LHC

REFERENCE LHC-JS-EC-0003

ENGINEERING CHANGE REQUEST

LSS1 - AFP small shielding walls

Figure 3 — Small shielding wall integration model for the AFP Patch Panel.

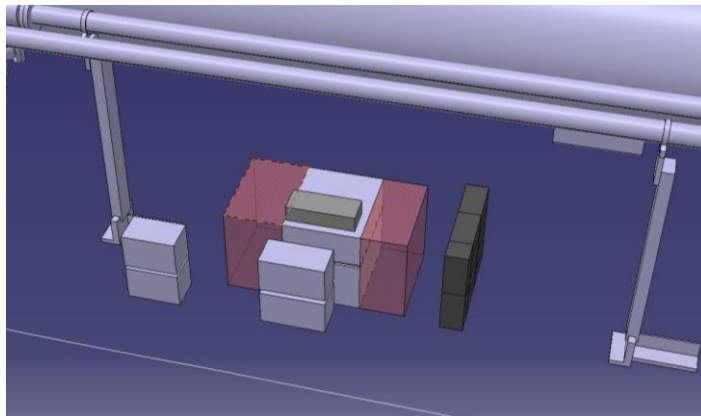
To minimize radiation damage as much as possible, and to reduce the AFP electronics failure probability, small shielding walls were proposed to be installed during TS1 in 2023 for the equipment inside the Patch Panel (VREG Controller Card and VREG Voltage Boards) which was breaking down at an increased pace and for which AFP had very limited spares. A quick solution, suggested by BE-EA-DC and accepted by EN-ACE-INT, was to use iron bricks of 20x10x10cm in size, for relatively easy manipulation and installation. A proposed solution for the Patch Panel is shown in Figure 3.

Figure 4 – Photos of installed small shielding wall in LSS1L

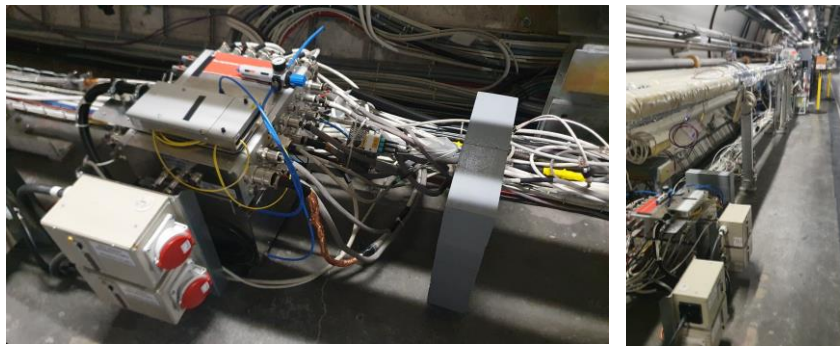
The solution was presented at the ICL meeting on 14.06.2023, accepted by LHC Integration and Coordination group representatives and finally the intervention was approved and validated by the LMC on the same day [5]. The shielding bricks were promptly prepared by BE-EA-DC and installed on 22.06.2023 during TS1. In the very end, used a total of 8 bricks per wall/side, consisting of two columns (2x4), as shown in Figure 4.

Figure 5 – Layout between AFP and TCL6 in LSS1L

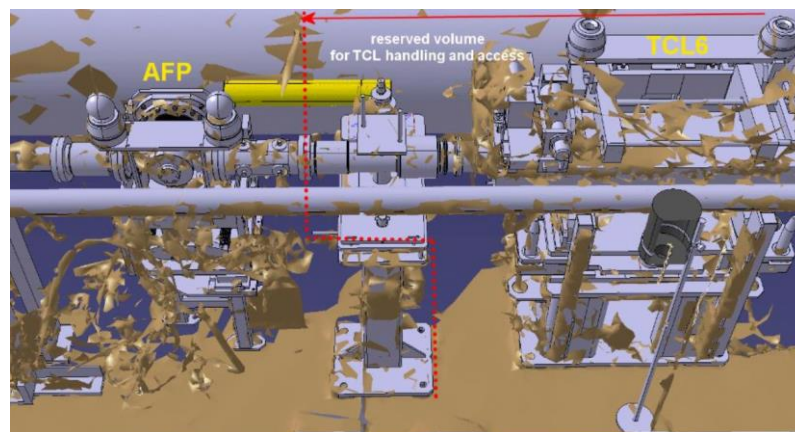
Another shielding wall was needed to protect AFP electronics in the so-called ToF crate located on the floor ~ 1 m from the TCL6. Due to limited space, there were strong constraints regarding available volume for any shielding wall – the solution must assure access to the TCL6, TE-VSC group equipment and BPM (see Figure 5), all of which had to be taken into account. Due to these limitations, it was suggested not to proceed with the small shielding wall installation next to TCL6.

Figure 6 – Small shielding walls (integration model and photos) in LSS1.

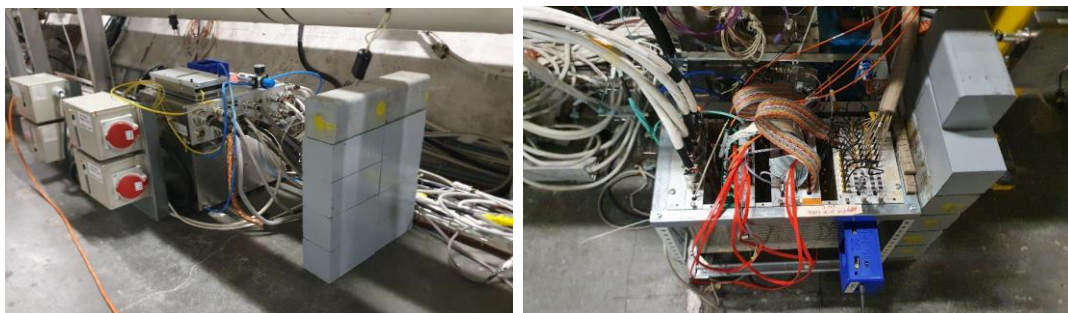
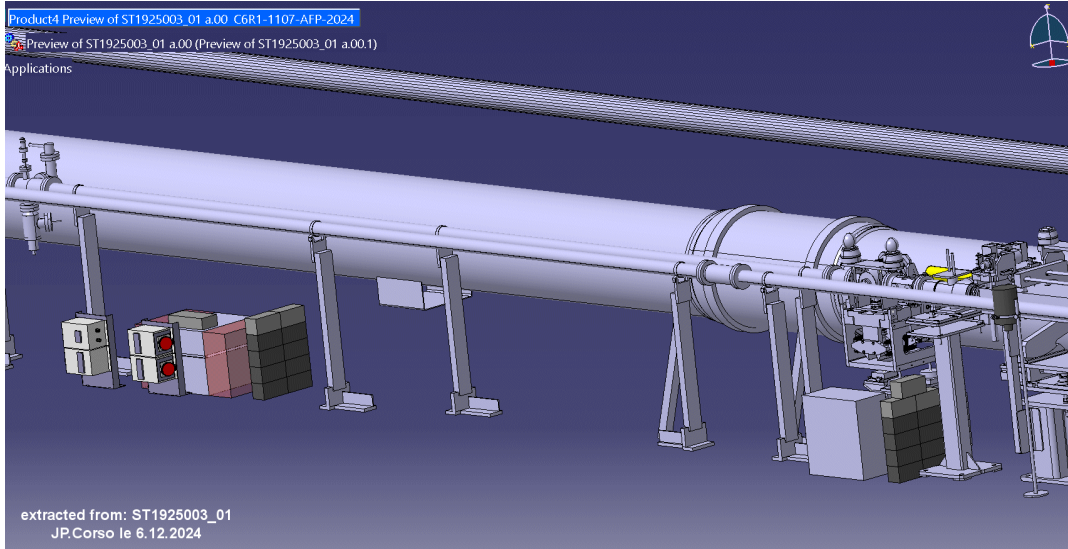
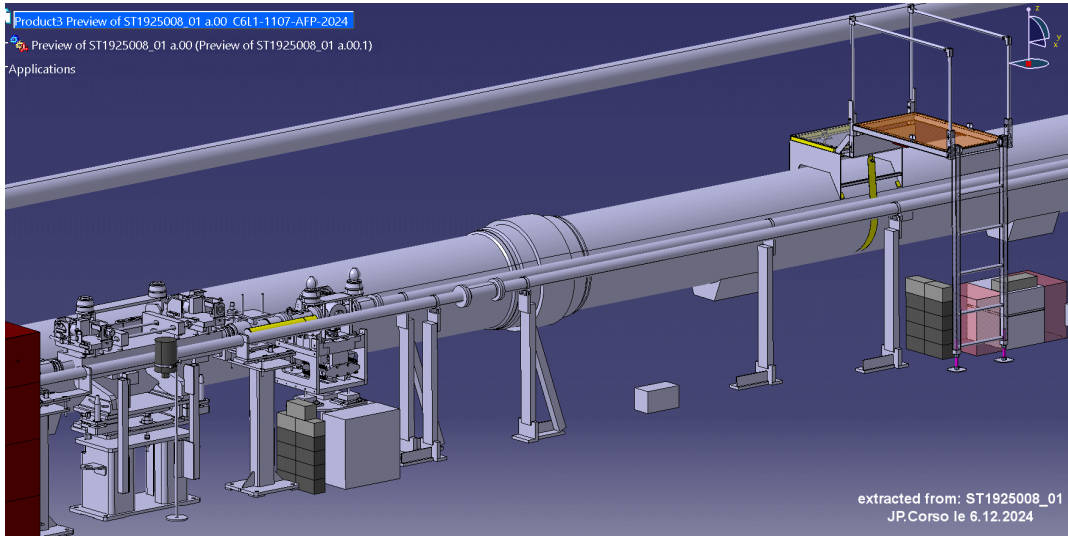
After in-situ inspection by EN-ACE-INT during TS1, a small space was identified just enough to install a similar shielding wall to the one for PP. It was also suggested to increase the height of the PP small shielding wall by additional 1 row of 2 bricks. Thanks to prompt approval by EN-ACE-INT/ISS and swift reaction by BE-EA-DC to supply additional bricks, the AFP was able to install the additional small shielding walls for the ToF crates on both sides (2 x 13 bricks each) and add one more layer of bricks (2) to increase the height of the PP shielding walls [6]. Figure 6 shows the integration model and how the shielding walls look like after installation and as they stand at the moment.
